Access Compliance Report

Public Rights-of-Way

(Curb Ramps)

Intersection ID: 27907	Main Street: BAY_HILL_CLUB_DR	Cross Street: COLONIAL_COUNTRY_LN	Location: SW
ADA ID: A804D97DFAA8	Ramp Type: Perp	Initial Pass/Fail: Fail	Overall Compliance: No
Severity Score: 8.75			
Codes/Mitigation Info/Possible Solution		Field Measurements/Component Compliance

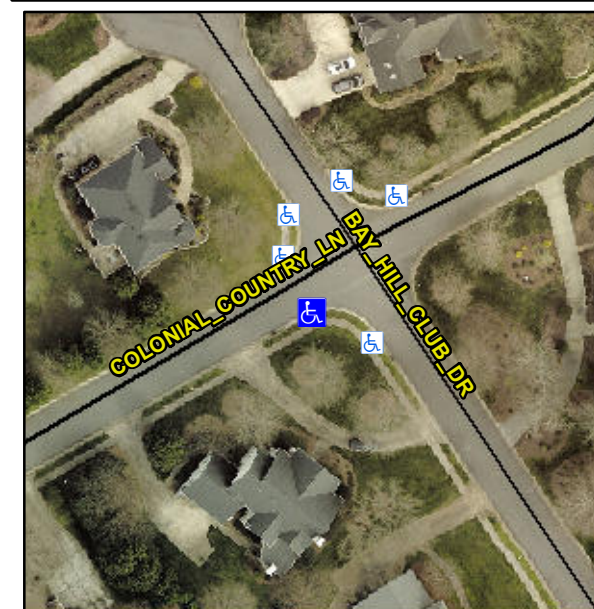
Not Found, R304.5.1

Compliance	Description	Data	Compliance	Description	Data
N/A	Ramp Length (in)	92.0	Yes	Ramp Slope (%)	7.3
No	Ramp Width (in)	46.0	Yes	Ramp XSlope (%)	0.5
N/A	Flare Type LT	N/A	N/A	Flare Type RT	N/A
N/A	Flare Slope LT (%)	N/A	N/A	Flare Slope RT (%)	N/A
N/A	Flare Traversable LT?	N/A	N/A	Flare Traversable RT?	N/A
N/A	Landing Length (in)	N/A	N/A	DWS Provided?	N/A
N/A	Landing Width (in)	N/A	N/A	DWS Contrast?	N/A
N/A	Landing Slope (%)	N/A	N/A	DWS Length (in)	N/A
N/A	Landing X Slope (%)	N/A	N/A	DWS Full Width?	N/A
N/A	Landing Curb? (Y/N)	N/A	N/A	DWS Offset (in)	N/A
N/A	Shared Landing?	N/A			
N/A	Gutter Ponding?	N/A	N/A	Gutter Slope (%)	N/A
N/A	Gutter Lip Ht (in)	N/A	N/A	Gutter X Slope (%)	N/A
N/A	Painted X Walk1?	No	N/A	Painted X Walk2?	N/A
	X Walk 1 Direction	To NW		X Walk 2 Direction	N/A
N/A	X Walk 1 Width (in)	N/A	N/A	X Walk 2 Width (in)	N/A
	X Walk 1 Slope (%)	1.6		X Walk 2 Slope (%)	N/A
	X Walk 1 X Slope (%)	0.2		X Walk 2 X Slope (%)	N/A

N/A	Ramp inside XWalk1?	N/A	N/A	Ramp inside XWalk2?	N/A
	Road Slope (%)	N/A	N/A	Clear Space?	N/A
	Road X Slope (%)	N/A	N/A	Clear Space to XWalk (in)	N/A
N/A	Any Obstructions?	N/A	N/A	Storm Grate/Utility Hazard?	N/A
	Obstruction Type			Storm Grate/Utility Type	
		N/A			N/A
			Yes	Surface Condition? (G/P)	Good

Remove & Replace Entire Ramp.
